SOLICITATION AMENDMENT
MODIFICATION DE L'INVITATION

Title - Sujet Simulator/Workshop Building	
Solicitation No. - N° de l'invitation F1700-110664/A	Amendment No. - N° modif. 001
Client Reference No. - N° de référence du client F1700-110664	Date 2012-05-29
GETS Reference No. - N° de référence de SEAG PW-\$PWY-020-6701	
File No. - N° de dossier PWY-2-35032 (020)	CCC No./N° CCC - FMS No./N° VME
Solicitation Closes - L'invitation prend fin at - à 02:00 PM on - le 2012-06-26	
F.O.B. - F.A.B. Plant-Usine: <input type="checkbox"/> Destination: <input checked="" type="checkbox"/> Other-Autre: <input type="checkbox"/>	
Address Enquiries to: - Adresser toutes questions à: Ly, Ronny(PWY)	Buyer Id - Id de l'acheteur pwy020
Telephone No. - N° de téléphone (604) 666-0043 ()	FAX No. - N° de FAX (604) 775-6633
Destination - of Goods, Services, and Construction: Destination - des biens, services et construction: DFO - Coast Guard Station - Bamfield, B.C.

Vous trouverez l'addenda n° 1 ci-joint.

This Addendum shall be read in conjunction with and considered as an integral part of the Contract Documents; revisions supersede the information contained in the original drawings, specifications or previ

PARTIAL SITE PLAN A1.1 -STEPS TO DRIVEWAY

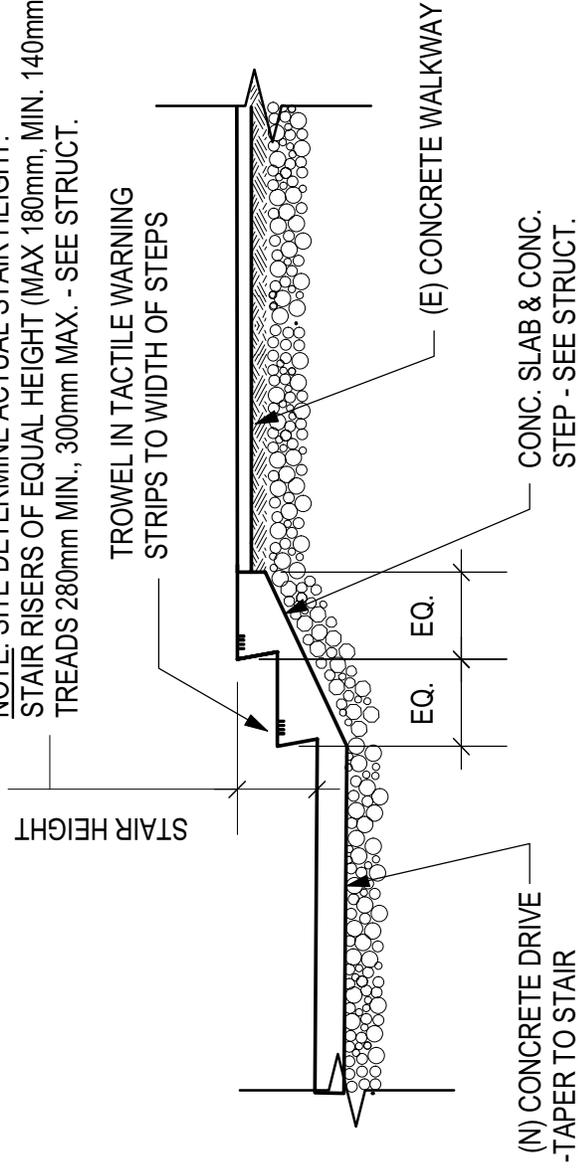
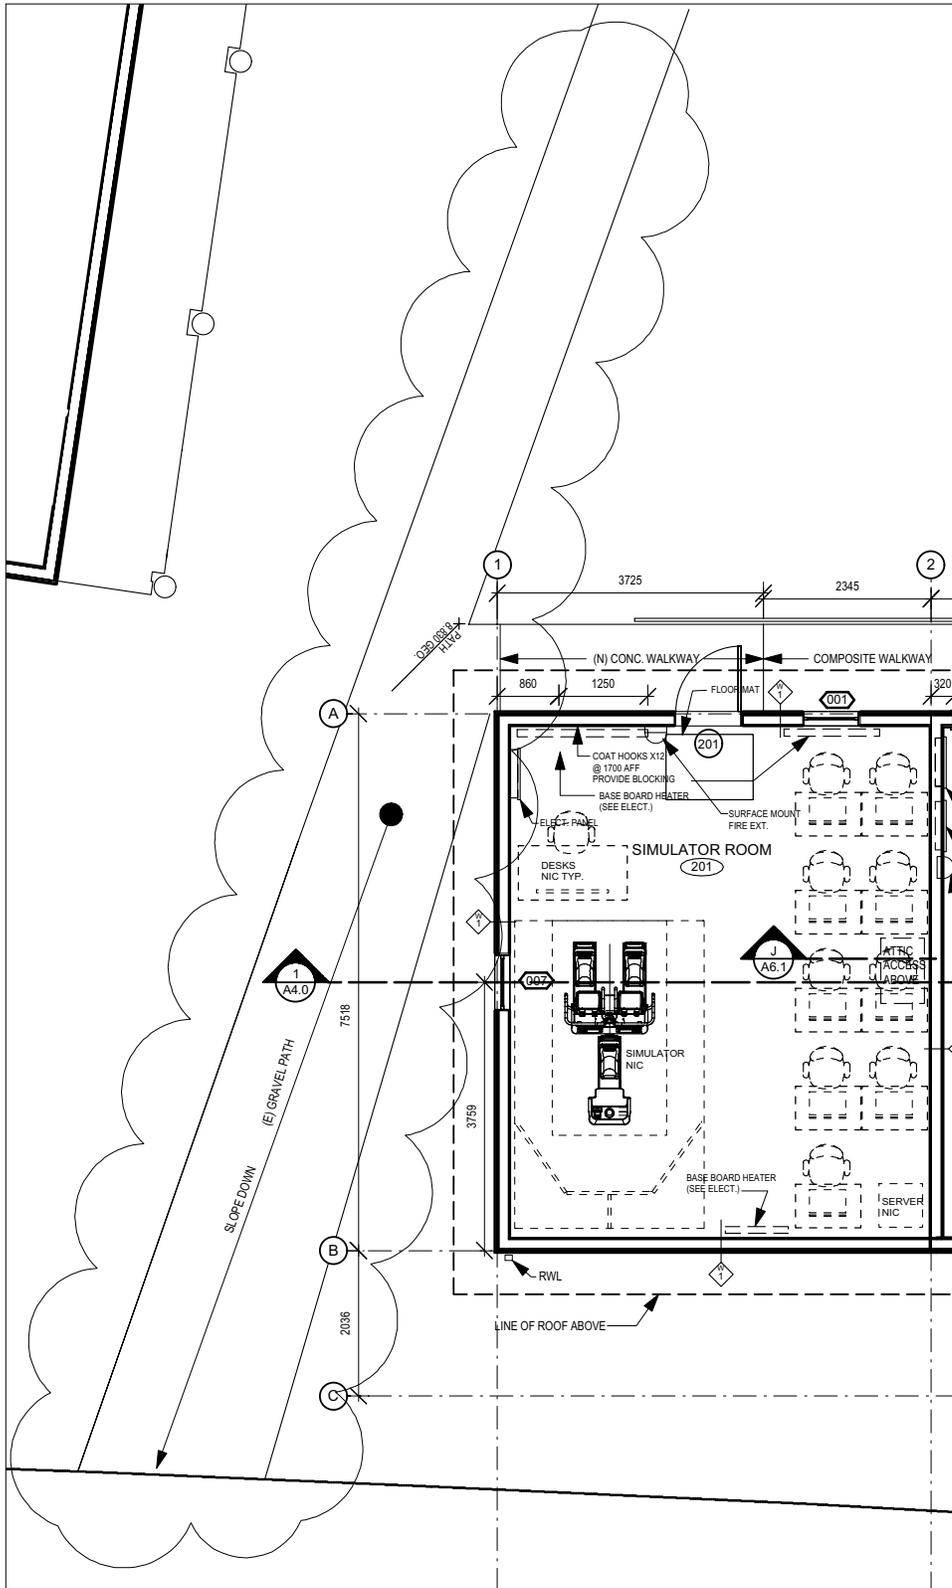
.1 See attached drawing ASK-01 for detail of steps from existing sidewalk down to the new driveway. Site determine actual stair height and confirm with NTAG and Structural before construction.

NOTE: SITE DETERMINE ACTUAL STAIR HEIGHT.
 STAIR RISERS OF EQUAL HEIGHT (MAX 180mm, MIN. 140mm)
 TREADS 280mm MIN., 300mm MAX. - SEE STRUCT.

PARTIAL SITE PLAN A1.1 -PATH

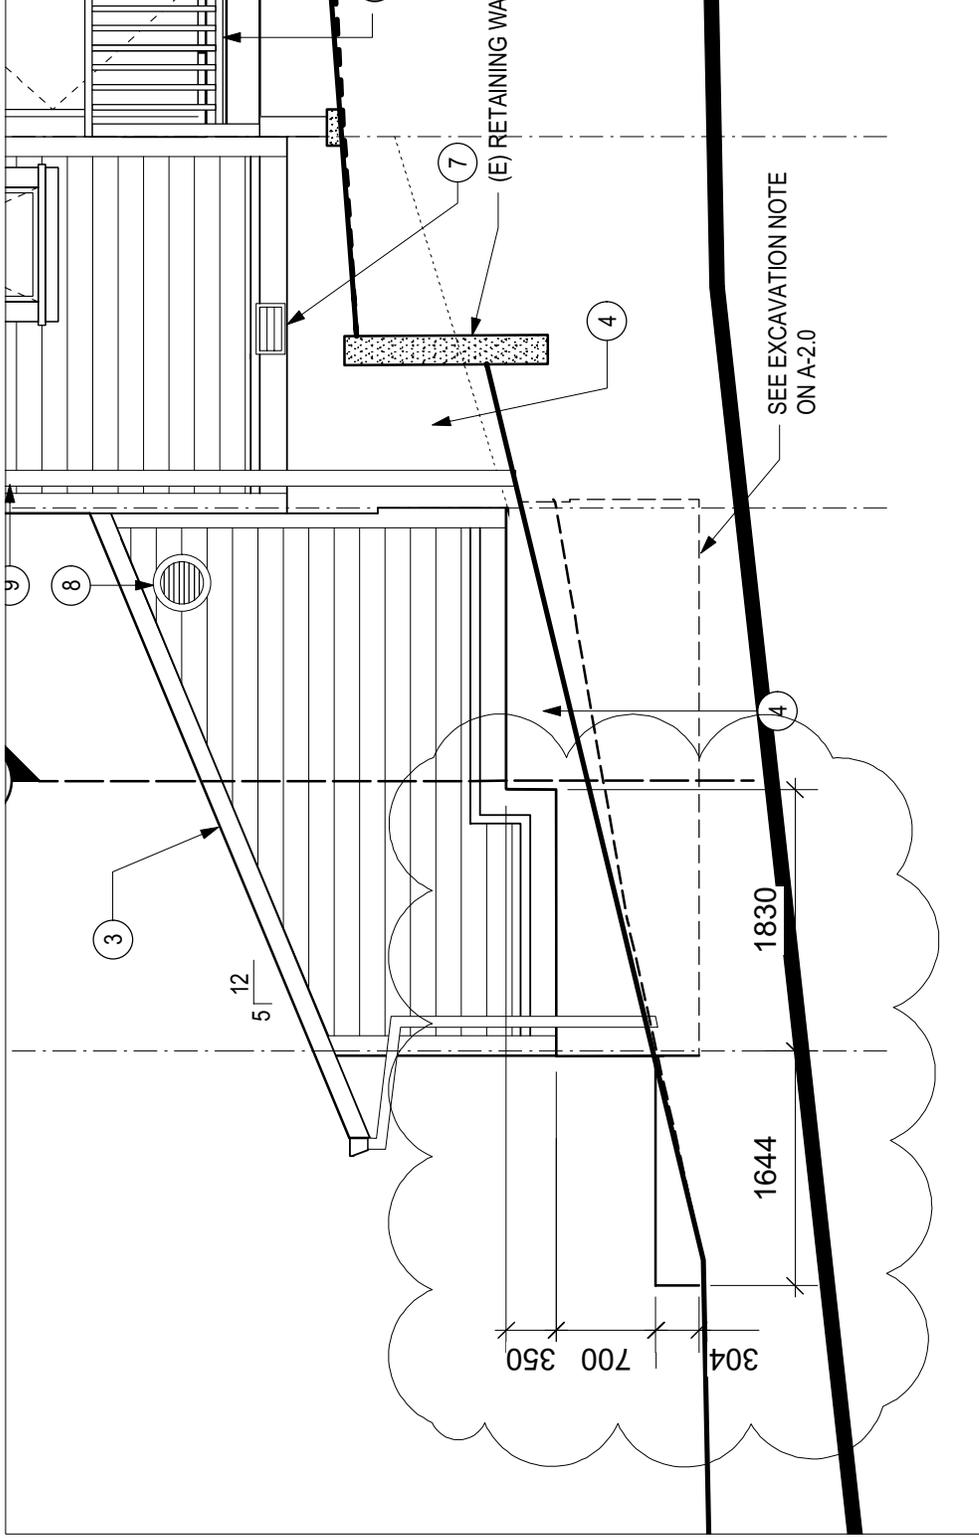
.2 Gravel path and concrete retaining wall are not included in tender contract. Gravel path as shown is existing. See ASK-02.

.1 Delete retaining wall and gravel path. See ASK-02

UPPER FLOOR/LOW ROOF PART PLAN

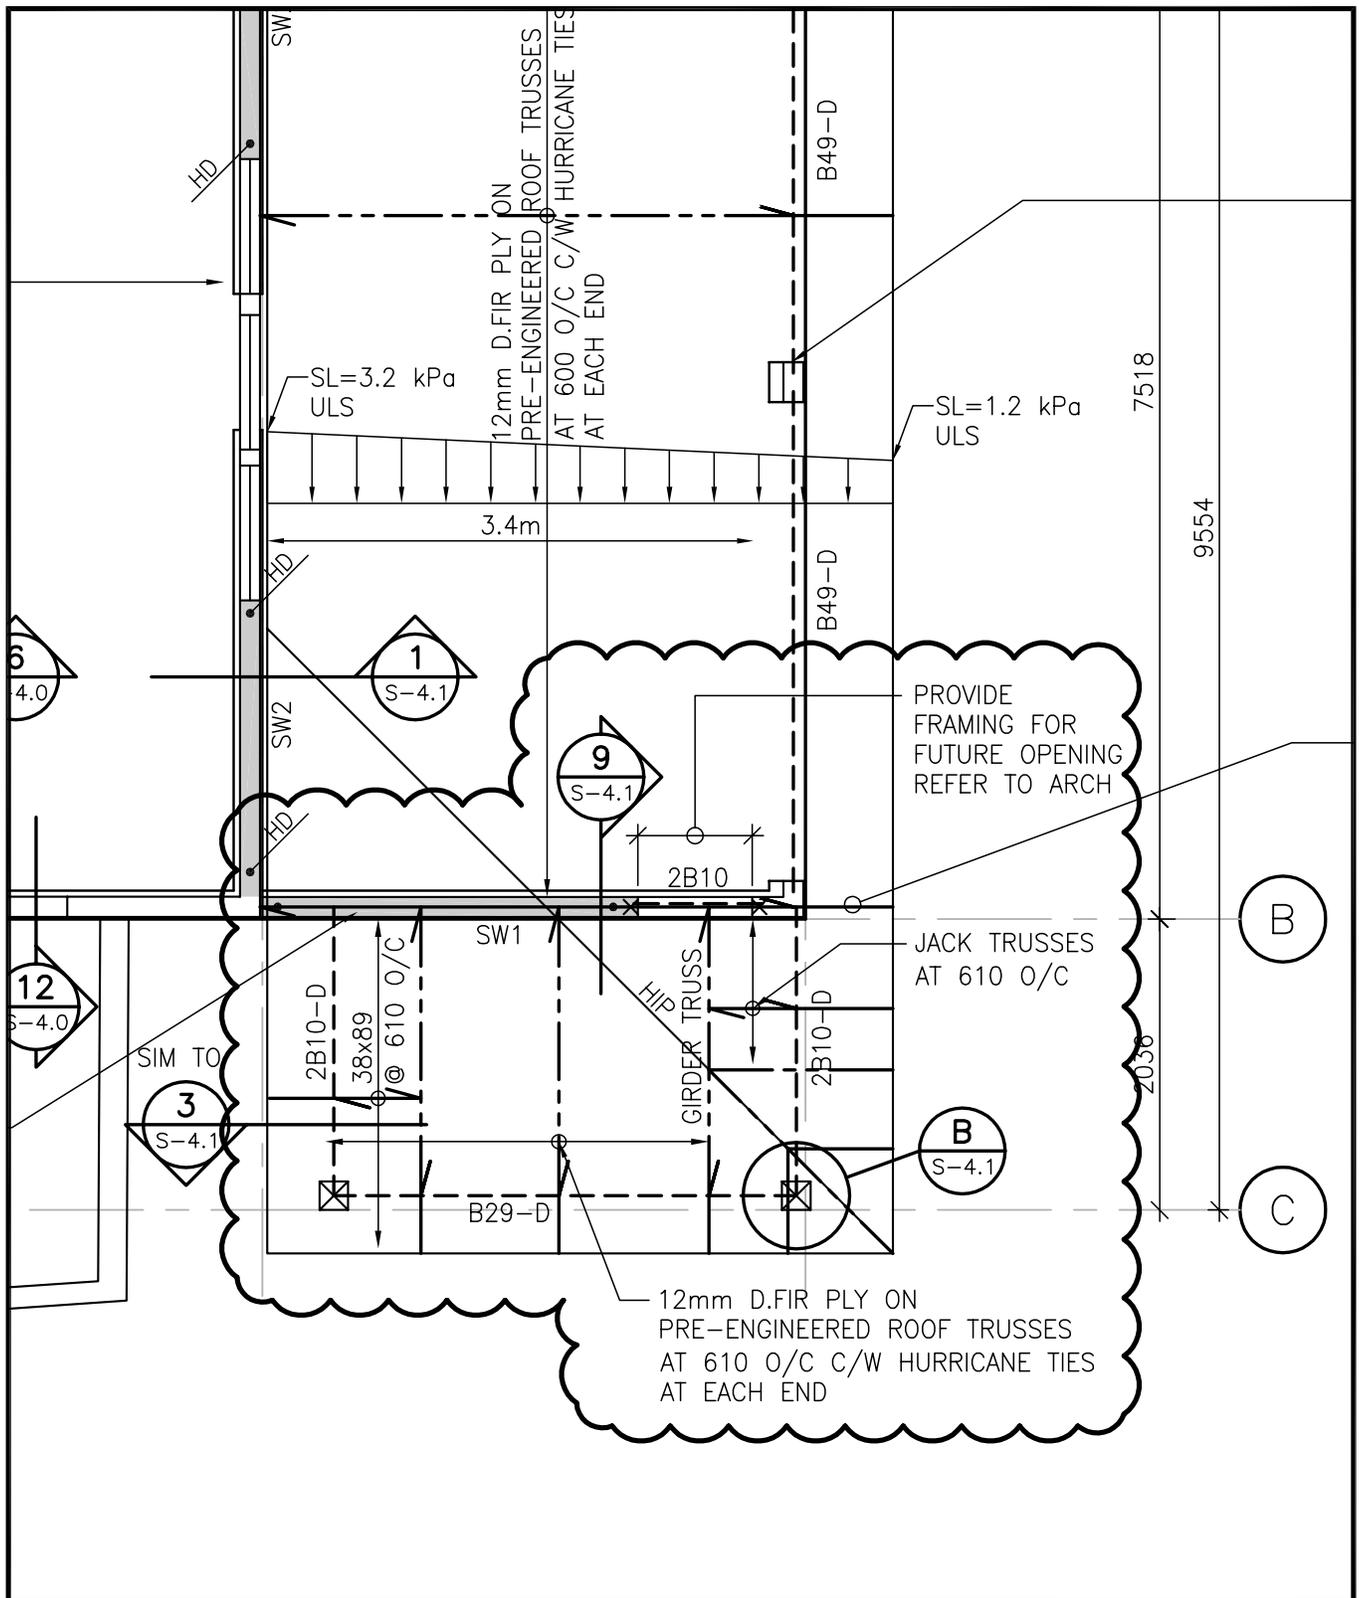
1. On 1/S-2.1 DELETE pressure treatment requirement noted by (*) for 2B10 along Grid A
2. Roof framing on 2/S-2.1 from Grid 4 to 5 and C to B to be REPLACED with details shown on SSK1.
3. REPLACE section 7/S-4.0 shown at Grid B/3+ and Grid A/3+ with 12/S-4.0 as shown on SSK2.
4. REPLACE section 1/S-4.0 at Grid B/4+ with 9/S-4.1 as shown on SSK6.
5. ADD SW1 text to shearwall along Grid A at 4+.

DRAWING NO:
SSK2

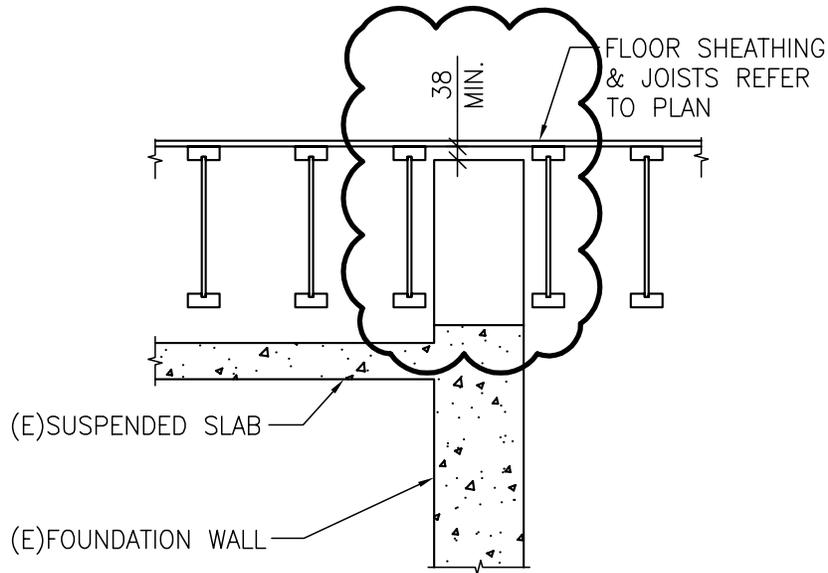
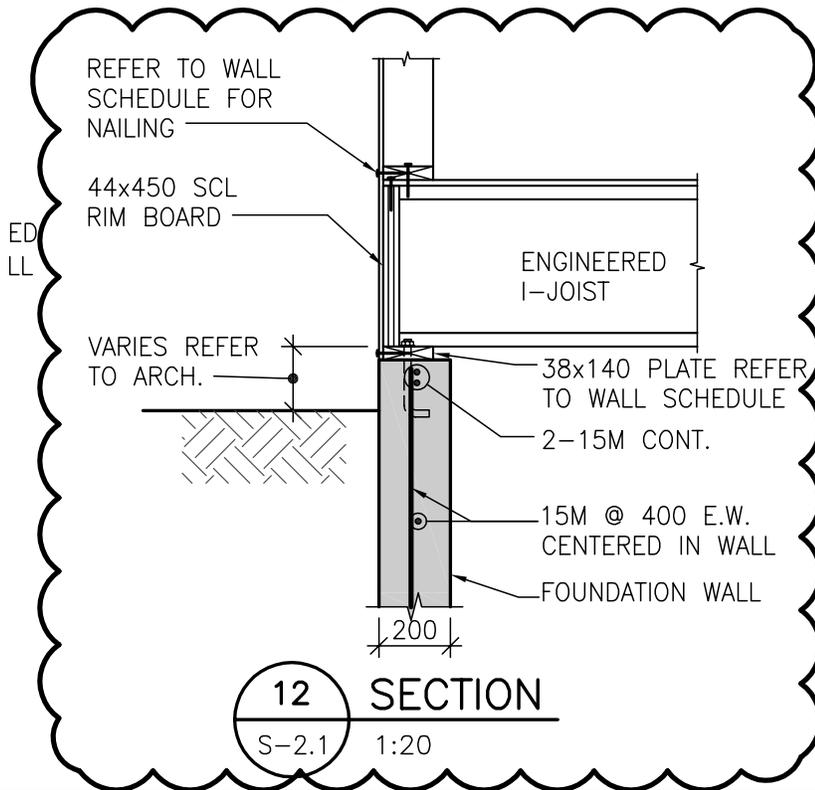
1. Section 1/S-2-0; block at upper floor REPLACE reference from 1/S2.1 to 1/S4.1
2. Section 4/S-2.0; ADD exterior concrete driveway to section.
3. Section 6/S-2.1; Provide gap between existing wall and TJI joist as per detail shown on SSK2.
4. DELETE section 9/S-2.0 and 10/S-2.0.
